Figure 143–13—MCRS Transmit Function, Transmit Process state diagram

Figure 143–15—MCRS Receive Function, Receive Process state diagram

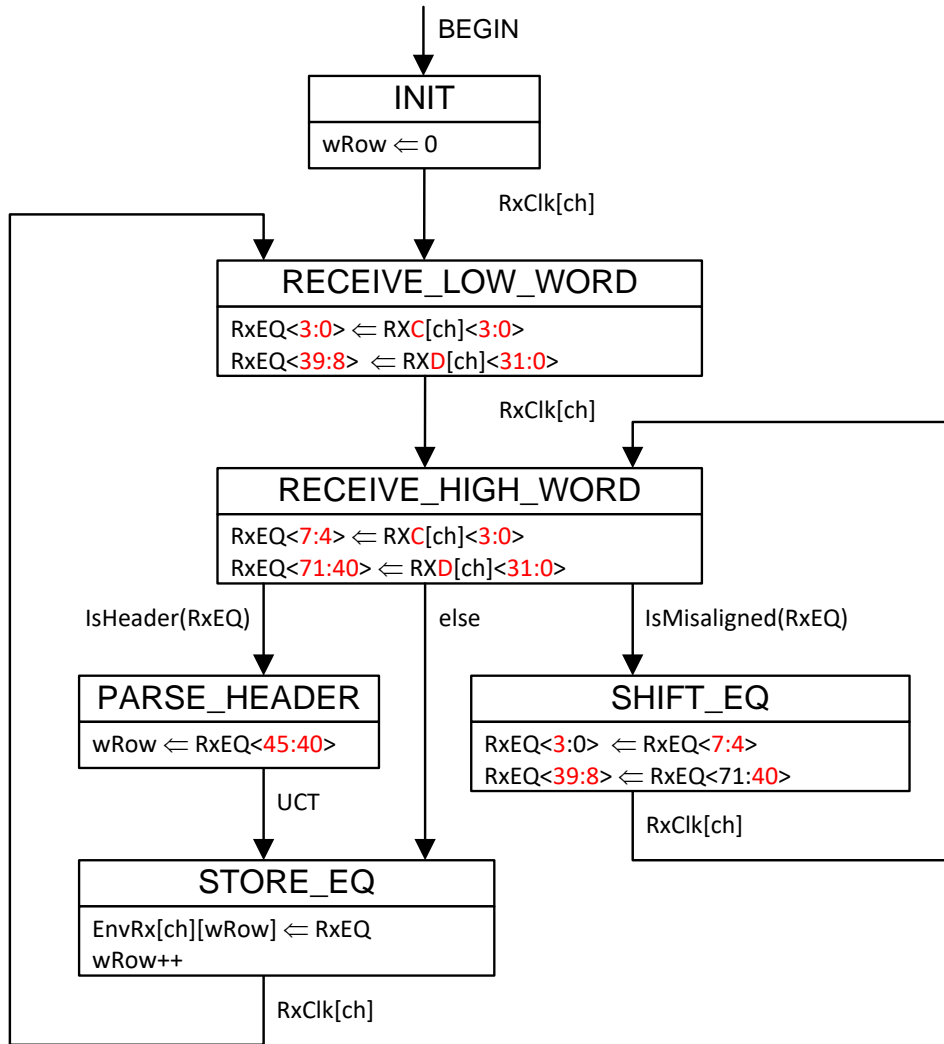
1) Corrected bit positions for the 1st and 2nd 25GMII transfers within an EQ
